# UNITED STATES PATENT AND TRADEMARK OFFICE

APPLICATION NO.	FILING DATE	FIRST NAMED INVENTOR	ATTORNEY DOCKET NO.	CONFIRMATION NO.
10/611,419	06/30/2003	Yee-Chung Fu	Q01-1041-US1 / 11198.71	5714
7590	10/24/2005		EXAMINER	CHEN, TIANJIE
The Law Office of Steven G. Roeder 5560 Chelsea Avenue La Jolla, CA 92037			ART UNIT	PAPER NUMBER
			2652	
DATE MAILED: 10/24/2005

### ***Final Rejection***

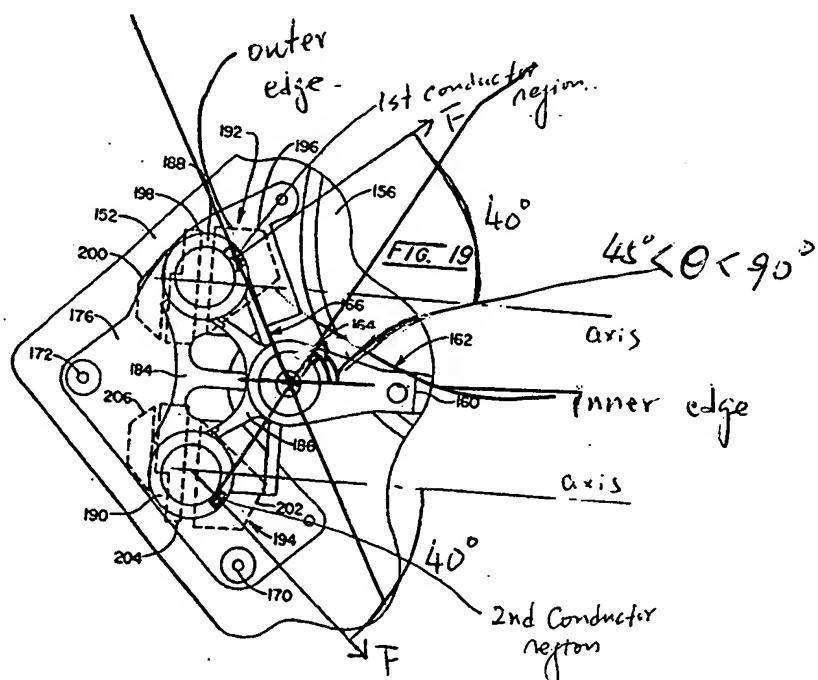
Claims 1, 32, 49, and 59; Wasson shows a disk drive including; an inherent storage disk having a plurality of tracks; a data transducer 18 (Fig. 2; column 6, line 18); an actuator assembly 162 (Fig. 19) that supports the data transducer over one of the tracks, the actuator assembly having a rotatable actuator hub 164 and a longitudinal axis (Fig. 20), the actuator hub being subjected to a resultant force that can cause track misregistration of the data transducer during movement of the actuator assembly; and a positioner that moves the actuator assembly relative to the storage disk, the positioner including (i) a magnet assembly 194+196 and etc. (Column 12, lines 44-64) that generates a magnetic field, and (ii) a first conductor region 188 (See Fig. 19 attached below with added marks) that cooperates with the magnet

assembly to generate a first force that is directed at an angle having an absolute value that is greater than zero degrees and less than approximately 45 degrees relative to the longitudinal axis of the actuator assembly inherently at least partially offset the resultant force at the actuator hub.

With regard to claims 49 and 59, Wasson further shows that the magnet assembly having an inner edge and an opposed outer edge relative to the actuator hub, and the first conductor region that is positioned between and defined by the edges of the first magnet (See the figure above).

Claims 2, 50, and 60; Wasson further shows a second conductor region 190 that cooperates with the magnet assembly to generate a second force (Fig. 19 above) that is directed at an angle having an absolute value that is greater than zero degrees

Claims 41, 55 and 64, Wasson further shows that the first conductor region and the second conductor region are positioned at an angle  $\theta$  having an absolute value that is greater than approximately 45/60 degrees and less than 90/89 degrees relative to the longitudinal axis of the actuator assembly (See Figure shown above).
